QUEENSTOWN LAKES DISTRICT COUNCIL

Hearing of Submissions on Proposed District Plan

Stream 15 Report

Report 19.6 – Chapter 38 Open Space and Recreation Zones

Figure 4: French, French and Burt property, as shown in Figure 36 of Mr Langman's Section 42A Report

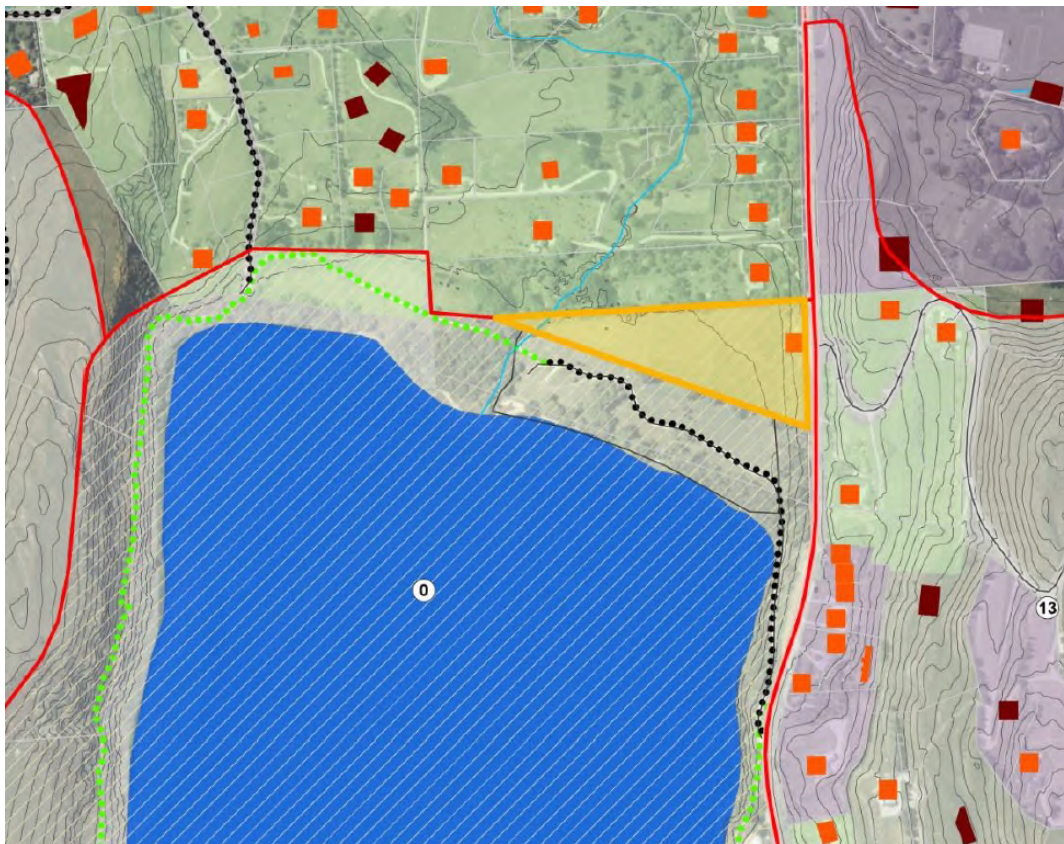
21. These submitters requested that 229 Arrowtown-Lake Hayes Road, as shown in Figure 4 below, be rezoned Precinct. The property was located within the ONF of Lake Hayes and zoned Rural Residential in Stage 1. Stage 2 did not alter the location of the ONF boundary, but zoned the property Rural Amenity. Ms Gilbert advised that the location of the ONL boundary appears to have been a mapping error.

22. In assessing this request, Mr Langman, relying on the evidence of Ms Gilbert, recommended that the ONF boundary be amended to exclude this property. He advised that Submission 177 provided the scope to make this amendment. We agree. Submission 177 sought the removal of the ONF/ONL notations from all land not zoned Rural. Mr French appeared at the hearing and supported the officers' recommendations.

23. We accept Mr Langman and Ms Gilbert's conclusions for the reasons they provided and recommend the ONF boundary is amended to exclude this property. We consider the zoning of this property in Section 3.2 below.

Figure 5: Recommended zoning of LCU 12

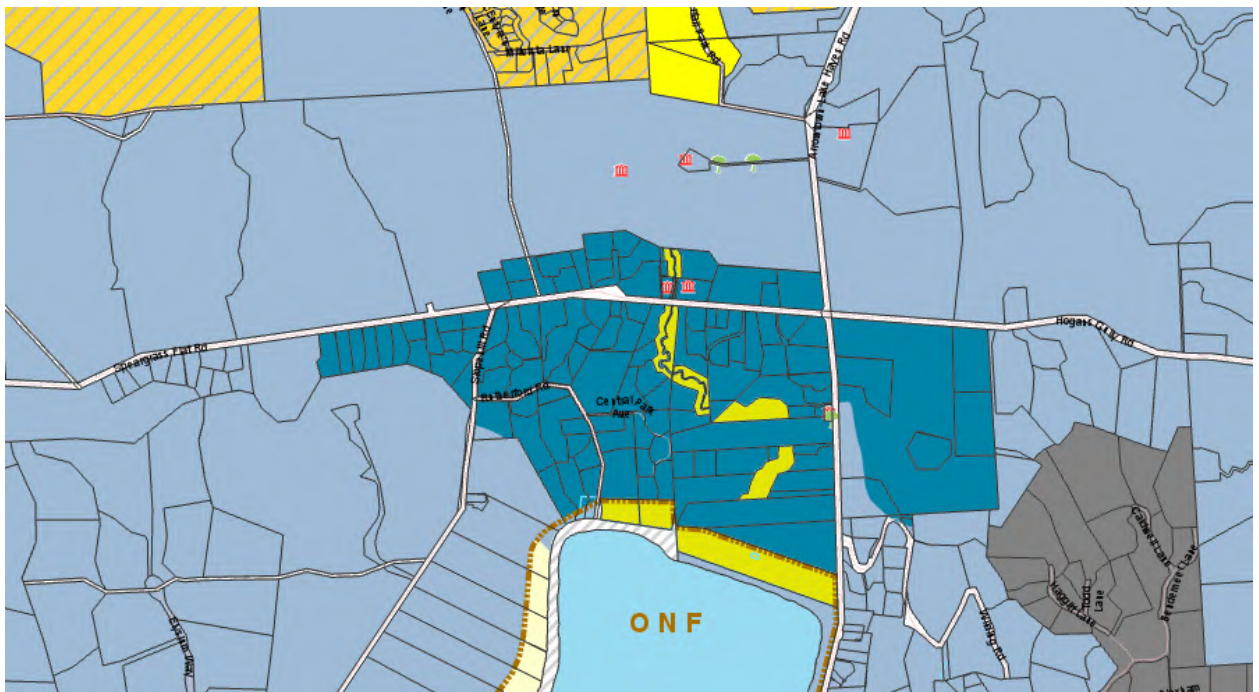
- b. the land outside the reticulated wastewater scheme boundary on Speargrass Flat Road, which, consistent with our findings in Section 2.8 of Report 18.1, we recommend should be rezoned Rural Amenity Zone.

35. Figure 5 below shows the recommended zoning pattern for this area.

Figure 6: Location of submissions, as shown in Figure 48 of Ms Gilbert's Evidence in Chief

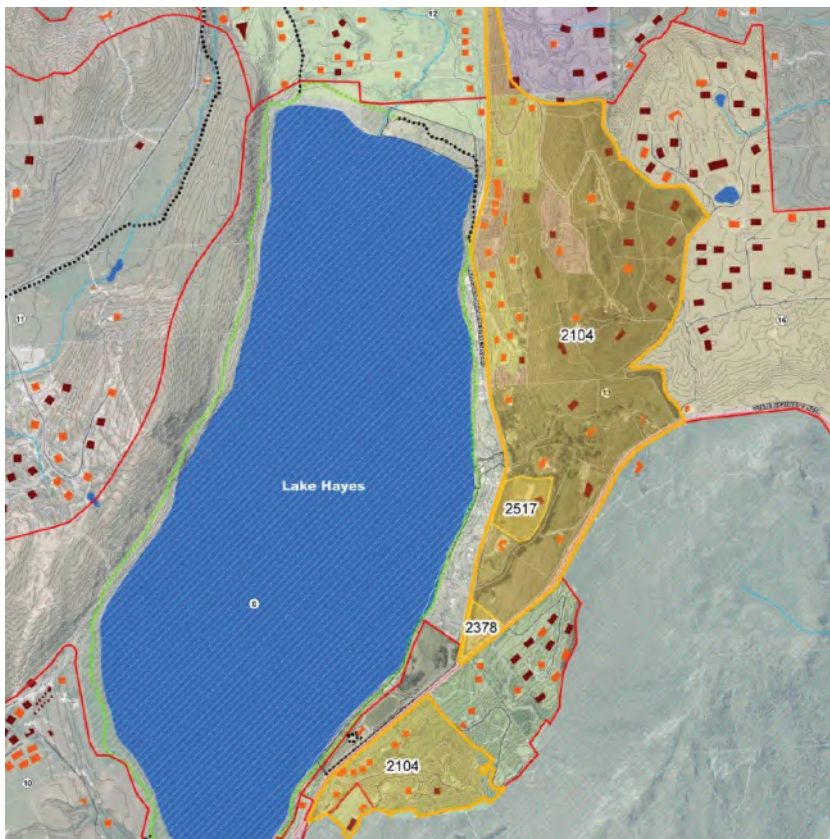
36. The area of concern in this LCU (excluding Amisfield Winery which we consider below) was the land up the slope from Arrowtown-Lake Hayes Road and State Highway 6. As notified, most of this land was zoned Rural Amenity. We have noted above a small area above State Highway 6 and within the ONL as notified which was zoned Rural Residential in Stage 1¹⁸. Mr Brown and Mr Espie provided evidence in support of the submissions seeking that much of this area be rezoned Precinct¹⁹. The submissions also sought site-specific provisions to enable an average density of 4,000m². We have dealt with the issue of densities and minimum and average lot sizes in Report 18.1. The area the subject of these submissions is shown in Figure 6 below.

37. The main issues relate to effects on water quality, landscape and planning.
